BID # 1253

BID PACKAGE
FOR
REHABILITATION/RECONSTRUCTION WORK TO
MASURY RESIDENCE
31 MOREHOUSE AVENUE
MILFORD, CONNECTICUT

ADDENDUM NO. 1

1 TYPICAL SOFFIT AT NON-PERIMETER LOCATIONS
SCALE: 3/4" = 1'-0"

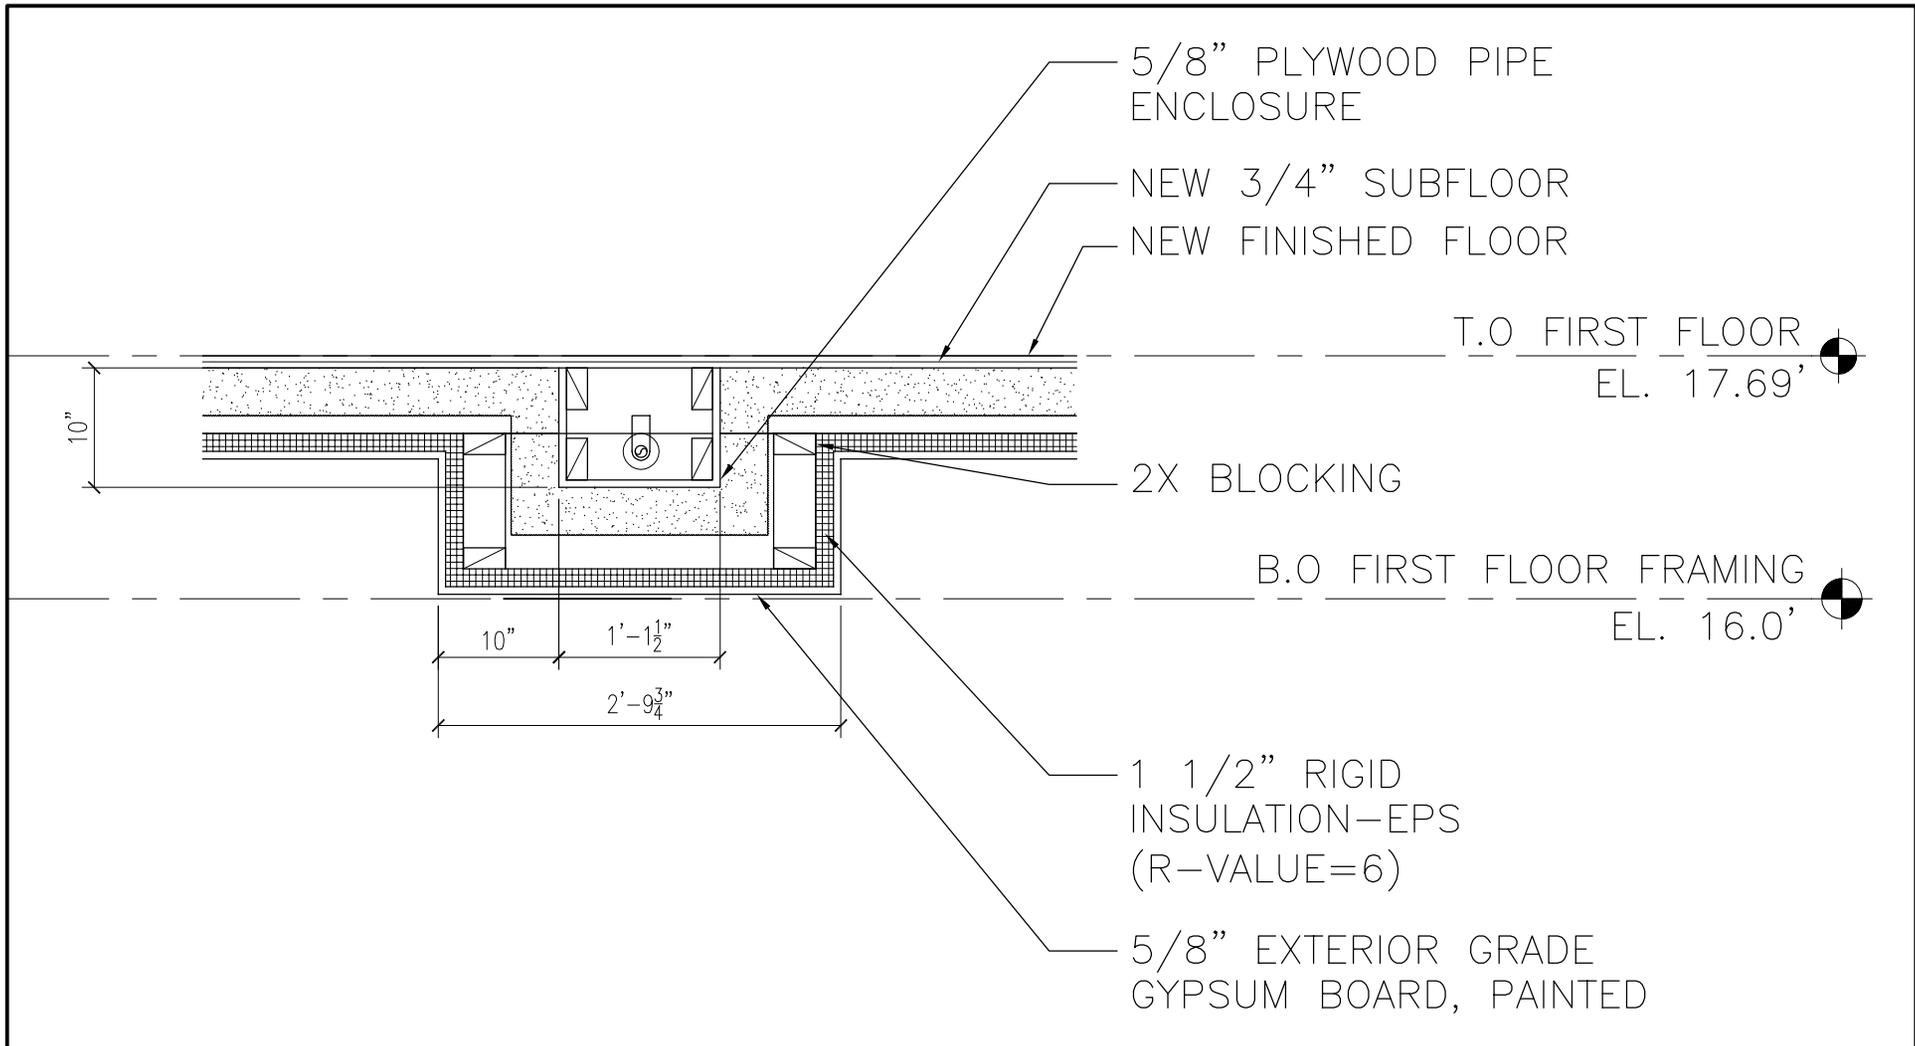
- 7. Sketch SK-001
 - a. Detail provided for soffits required for piping at non-perimeter locations.
